LIMERICK GENERATING STATION  
UNITS 1 and 2

TECHNICAL SPECIFICATIONS CHANGE REQUEST

No. 91-04-0

"Revision of Snubber Functional Testing  
Surveillance Requirements"

Figure 4.7.4-1

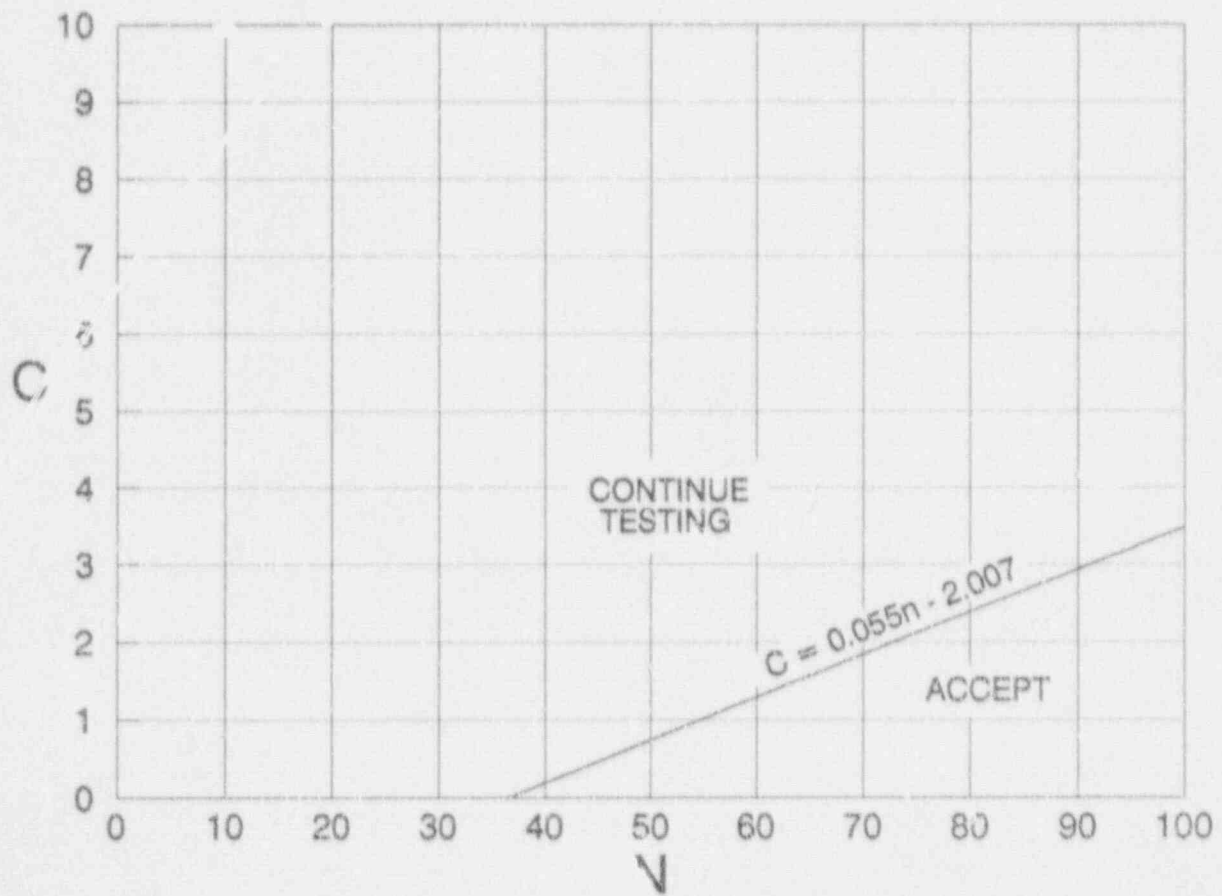
The 37 plan (i.e., SR 4.7.4.e.2) uses TS Figure 4.7.4-1 to determine the need to continue testing. The "accept" line of this figure is based on the equation  $C = 0.055N - 2.007$  where 'N' is the number of snubbers of a type that is tested, and 'C' is the total number of snubbers of a type not meeting the TS acceptance requirements. This equation was developed using "Wald's Sequential Probability Ratio Plan," as described in "Quality Control and Industrial Statistics," by Acheson J. Duncan. The equation used in ASME OM4 has the same basis except it has been rearranged for clarity. The revised 10% plan exactly matches the 37 plan at a population of 370 snubbers which gives the 10% plan statistical significance in its revised form. The original form of the 10% plan was not based on statistics so adaptation of the revised form will allow this plan to be consistent with current industry practices.

Removal of the "reject" line from the 37 plan is justified for the following reason. The FMG eliminates the need to test all snubbers of a certain type and allows normal testing to continue with added focus on the specific mechanisms causing failures. Also, removal of the "reject" line does not preclude the possibility that all snubbers of a given type will be tested as an FMG, if required by the test results.

- b. Removal of the "reject" line from the 37 plan, which results in an expanded "continue testing" region, will not reduce the effectiveness of the plan to detect failed or degraded snubbers. Snubber testing must still continue until the test results fall within the "accept" region or until all snubbers are tested, thus providing the same statistical confidence in the completed test.

- 2) A representative sample of 37 snubbers of a snubber type shall be functionally tested in accordance with Figure 4.7.4-1. "C" is the total number of snubbers of that type found not meeting the acceptance requirements of Specification 4.7.4f. The cumulative number of snubbers of the type tested is denoted by "N". If at any time the point plotted falls in the "Accept" region, testing of snubbers of that type may be terminated. When the point plotted lies in the "Continue Testing" region, additional snubbers of that type shall be tested until the point falls in the "Accept" region, or all the snubbers of that type have been tested.
